Changed ground terminal position

Product Change Notification						PCN FMBB and FSS case 48 redesign		
owner	creation date	release date	released by	change order no	rev	page	D40 057 000	
doriaan	12.05.2021	12.05.2021	blumhe	2021809	В	1 of 2	D10-057-322

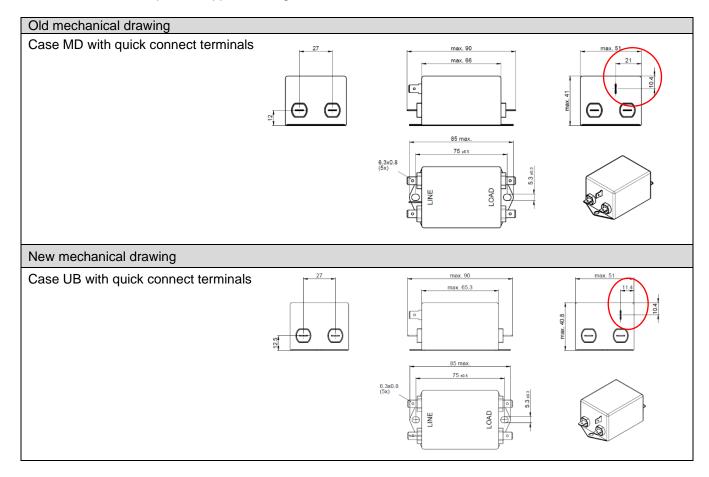
Modification of the product appearance, ground faston terminal moved

Form Yes Note new ground terminal position
